SLIC: 425 TENNANT AVENUE, MORGAN HILL; REMEDIAL ACTION WORK PLAN & 90% DESIGN REPORT FOR SOIL REMEDIATION, 425 TENNANT AVENUE FACILITY, SANTA CLARA COUNTY

Re: Comments on "Remedial Action Work Plan & 90% Design Report for Soil Remediation, Olin/Standard Fusee Site, Morgan Hill, California"

Subject: Comments on Remedial Action Work Plan & 90% Design Report for Soil Remediation, Olin/Standard Fusee Site, 425 Tennant Avenue, Morgan Hill, California

Area of concern mentioned in Regional Board staff's RAWP letter.

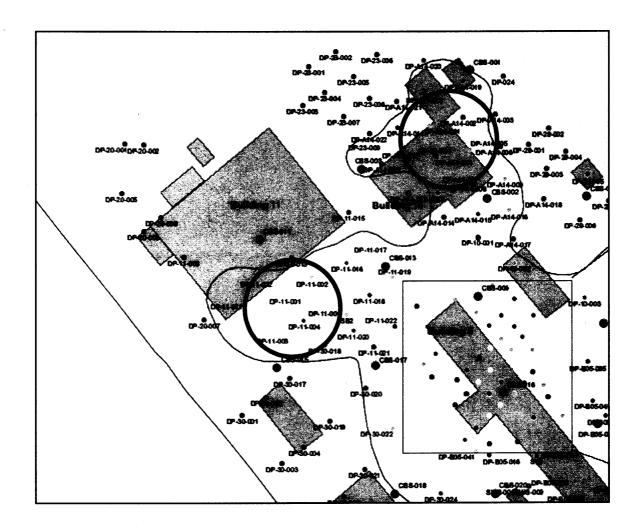
- b. There are two areas with elevated concentrations of perchlorate that have confirmation soil borings situated in either outside the 50 µg/kg area or are just inside. The attached figure shows the locations of these two areas. Regional Board staff requests that a sample boring be located in the middle of these areas. Our request is based on the fact that confirmation soil borings are located in high concentration areas, and the goal of soil sampling plan should not merely be to set up a random sampling grid, but to also confirm that areas with high concentrations are remediated.
